**ADDENDUM NUMBER: TWO**

**ISSUED BY: SEPW Architecture Inc.**  
109 – 3725 Pasqua St., Regina, SK. S4S 6W8

**PROJECT: INTERIOR FIT-UP PHASE 2  
REGINA, SASKATCHEWAN**

This Addendum forms part of the Contract Documents and amends the original Drawings and Specifications dated 2017-02-03, previous Addenda if applicable and as noted below. This Addendum consists of **13** pages.

DRAWING TITLE  
ADDITIONAL MAGNETIC GLASS BOARD ELEVATIONS

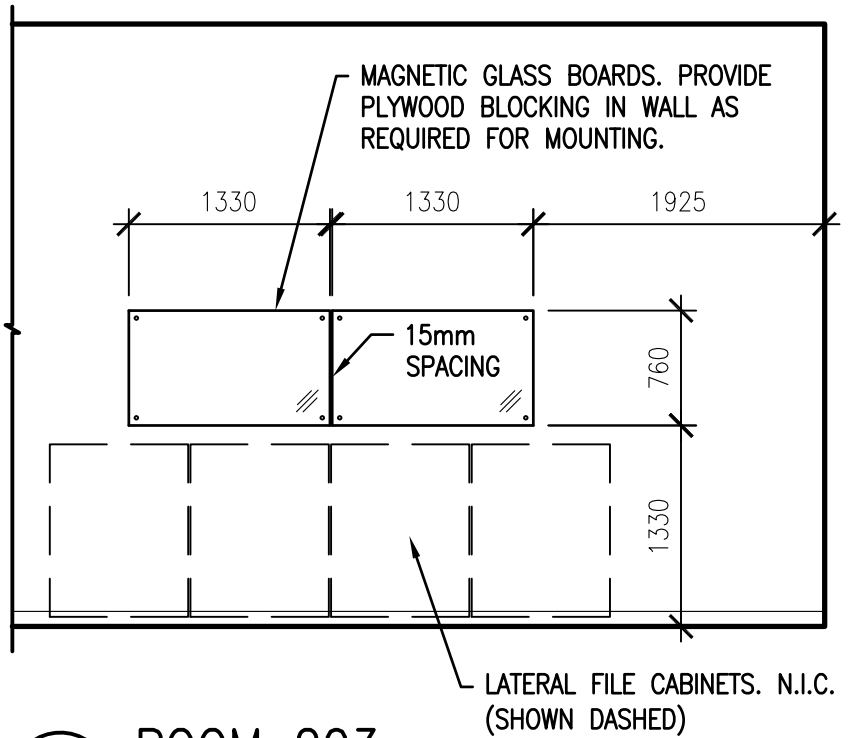
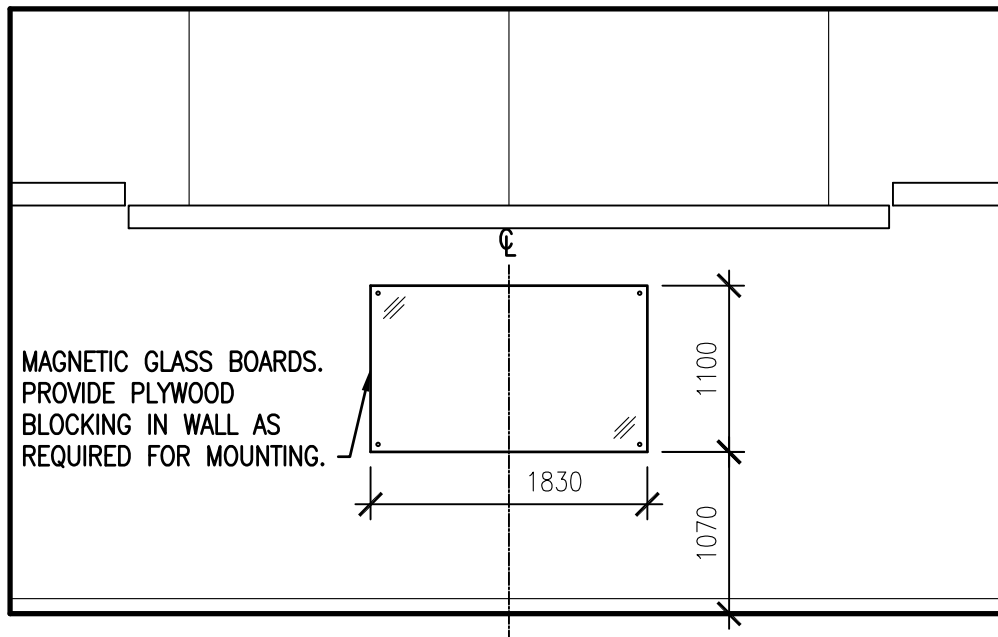
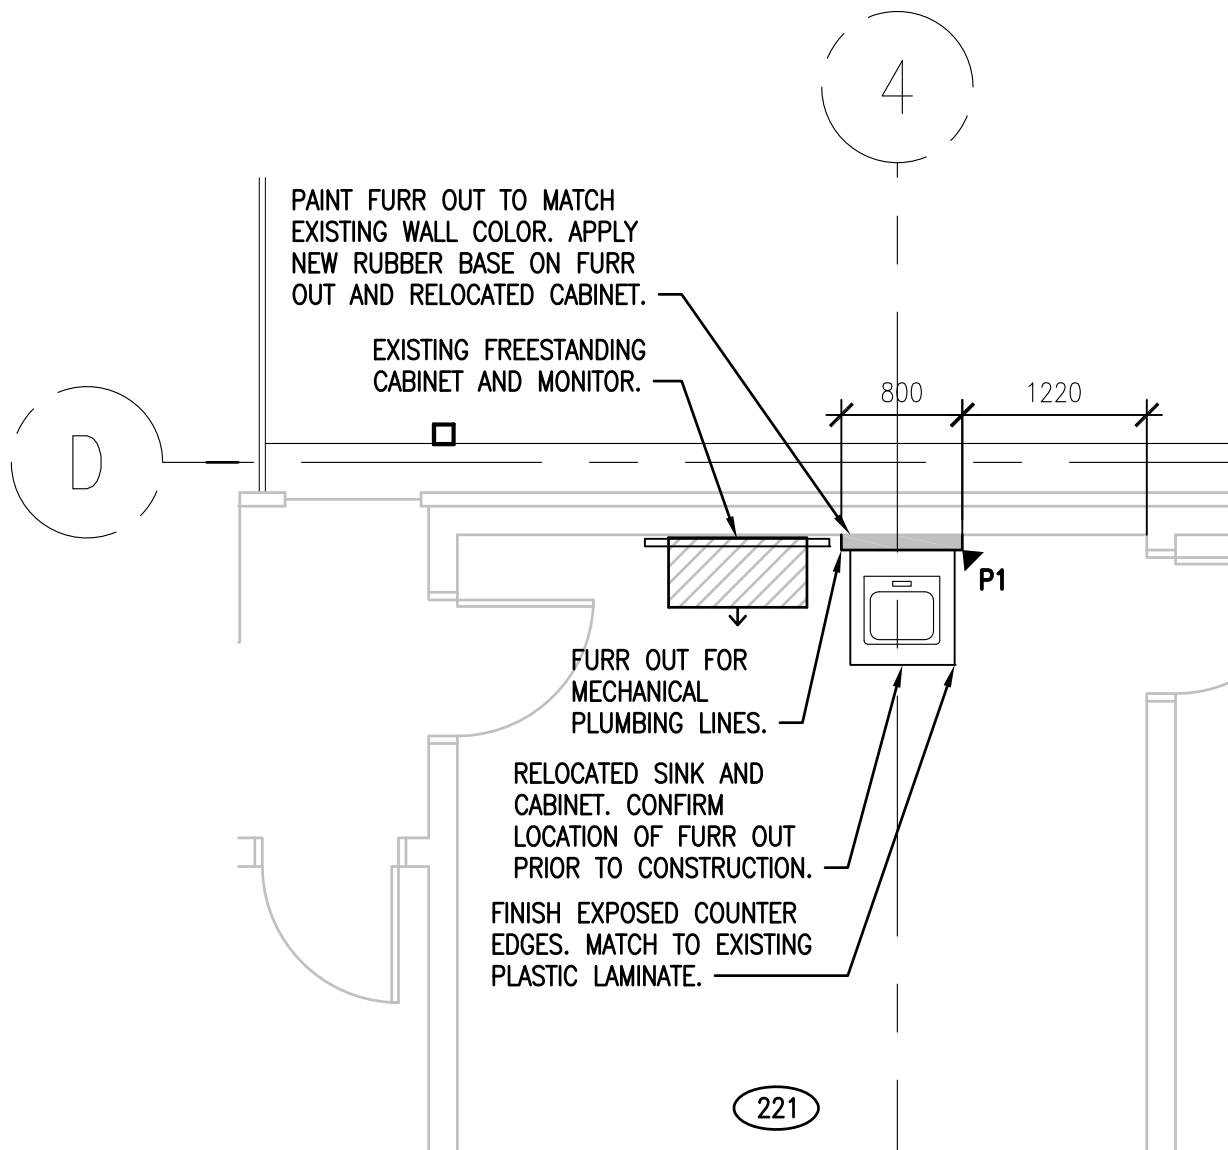
Q13: Please confirm the quantity and sizes of magnetic boards as there are a couple call up's for blocking but no elevations to show the quantity/size required.

Q26: Please advise requirements for glass boards in Area 203. Floor plan notes blocking for glass boards to be installed in 3 locations in Area 203, but elevations shown only one location.

A13: *Refer to AR-6 for additional elevations of magnetic glass boards required. Below is a complete schedule of magnetic glass boards.*

A26: *Refer to AR-6 for additional elevations.*

Drawing title/Titre du dessin  
**SURFACE GRADING**

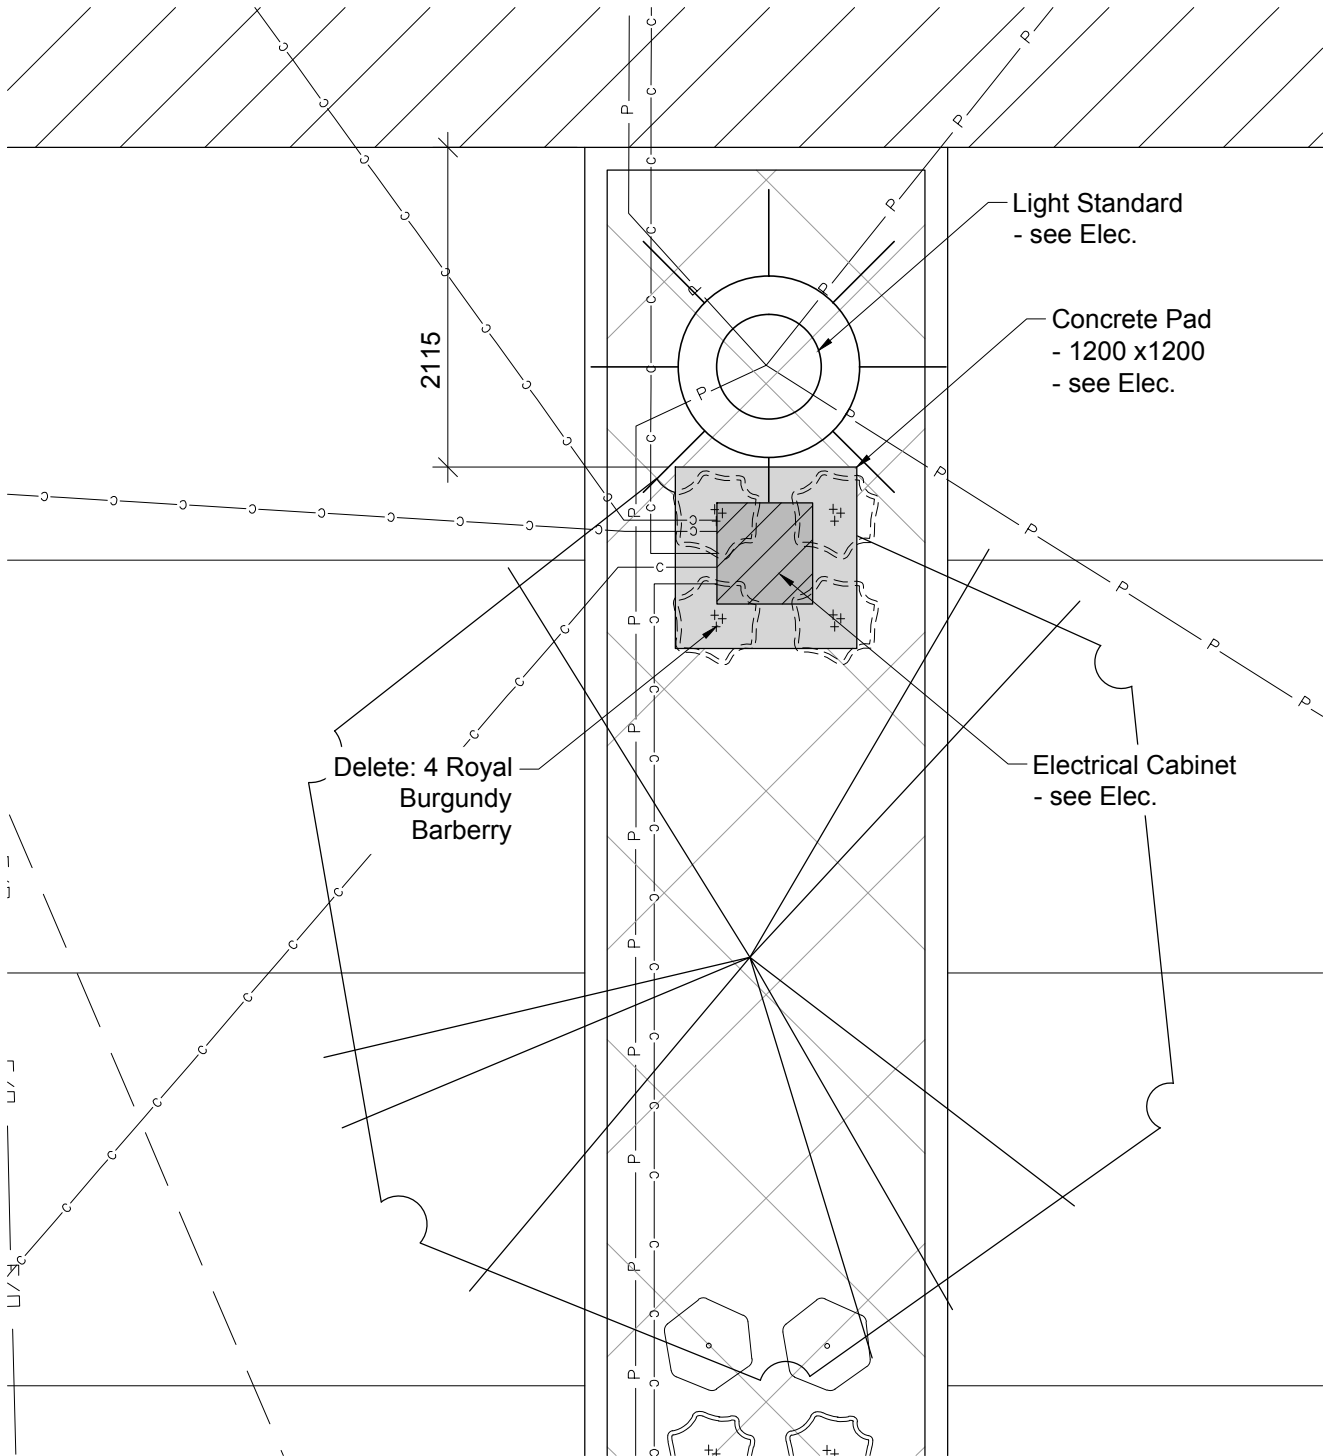
**A-2-36 REF. DRAWING C1.1 SURFACE GRADING (REVISION 1 – Attached to this Addendum)**

- .1 Add: Note 8 to read as follows: “Prior to construction the City of Regina will be installing a manhole within the asphalt surface for access to a deep sanitary sewer trunk. The location and rim elevation of the proposed manhole is unknown. When pricing, assume no additional manhole material is required.”
- .2 Revise: Notes related to “Proposed Berm” to read as “Berm”.

Q16: Please provide existing topographical plan of the site in order for us to determine the required cut/fill quantities for the earthwork required. Alternatively, provide an assumed existing elevation to base calculations off of and to ensure all GC's are pricing the same scope.

A16: *Refer to the revised C1.1 dated 2017-06-02 attached to this Addendum.*
